Access Compliance Report

Public Rights-of-Way

Intersection ID: 11273	Main Street: E_21ST_ST	Cross Street: N_DAVIDSON_ST	Location: NW
ADA ID: 271E56A59AFA	Ramp Type: Perp	Initial Pass/Fail: Fail	Overall Compliance: No
Severity Score: 33.75			
Codes/Mitigation Info/Possible Solution		Field Measurements/Component Compliance

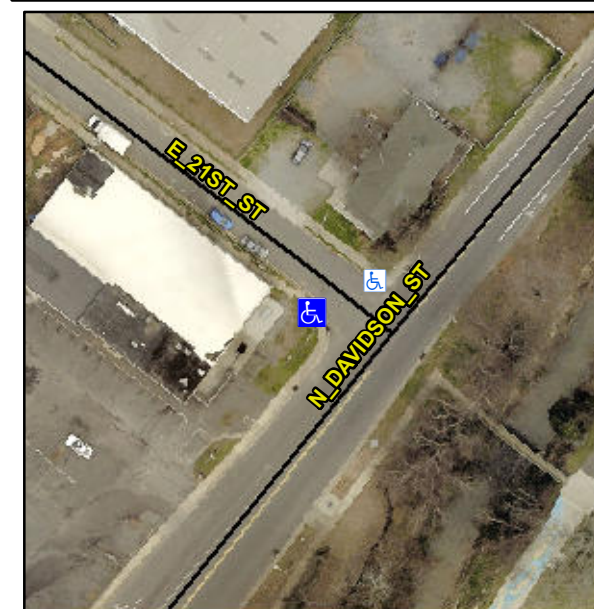
Not Found, R304.5.1, R304.5.3

Compliance	Description	Data	Compliance	Description	Data
N/A	Ramp Length (in)	47.0	Yes	Ramp Slope (%)	6.6
No	Ramp Width (in)	41.5	No	Ramp XSlope (%)	8.3
N/A	Flare Type LT	N/A	N/A	Flare Type RT	N/A
N/A	Flare Slope LT (%)	N/A	N/A	Flare Slope RT (%)	N/A
N/A	Flare Traversable LT?	N/A	N/A	Flare Traversable RT?	N/A
N/A	Landing Length (in)	N/A	N/A	DWS Provided?	N/A
N/A	Landing Width (in)	N/A	N/A	DWS Contrast?	N/A
N/A	Landing Slope (%)	N/A	N/A	DWS Length (in)	N/A
N/A	Landing X Slope (%)	N/A	N/A	DWS Full Width?	N/A
N/A	Landing Curb? (Y/N)	N/A	N/A	DWS Offset (in)	N/A
N/A	Shared Landing?	N/A			
N/A	Gutter Ponding?	N/A	N/A	Gutter Slope (%)	N/A
N/A	Gutter Lip Ht (in)	N/A	N/A	Gutter X Slope (%)	N/A
N/A	Painted X Walk1?	No	N/A	Painted X Walk2?	N/A
	X Walk 1 Direction	To NE		X Walk 2 Direction	N/A
N/A	X Walk 1 Width (in)	N/A	N/A	X Walk 2 Width (in)	N/A
	X Walk 1 Slope (%)	4.2		X Walk 2 Slope (%)	N/A
	X Walk 1 X Slope (%)	7.1		X Walk 2 X Slope (%)	N/A

Remove & Replace Entire Ramp.
